Reviewer #1

In their manuscript "A multi-disciplinary analysis of the exceptional flood event of July 2021 in central Europe. Part 1: Event description and analysis", Susanna Mohr and colleagues provide an overview of the disastrous July 2021 flood event.

Abb. 2: Freier Bodenwasserspeicher auf einer 60 cm dicken Bodenschicht unter Gras und einem realistischen Boden nach BÜK 1000 vor der Unwettersituation am 12.07.2021. Quelle: DWD, Agrarmeteorologie

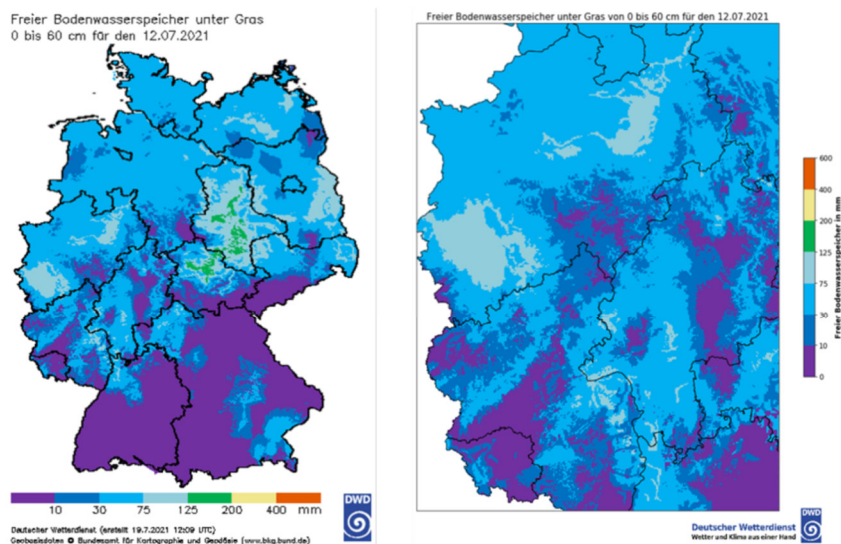
LI. 345 ff.: “In the southern parts of the Eifel, the Ardennes in the north-west, and in the north-east of the study area in the Wupper region, generally less than 10 mm of soil water storage were still available for infiltration. In the remaining regions, free soil water storage was larger, but still below average, ranging mainly between 10 and 30, sometimes 75 mm.” On which basis are these statements made? The API does not allow for such an assessment (by the way, since the API is only computed from precipitation, it is basically a meteorological quantity, not a hydrological one).

Thank you for pointing this out. The API indeed does not allow statements on available soil water storage. The statements were made based on Fig. 2 in Junghänel et al. (2021) (see below). We will make this clear in a revised version of the manuscript.
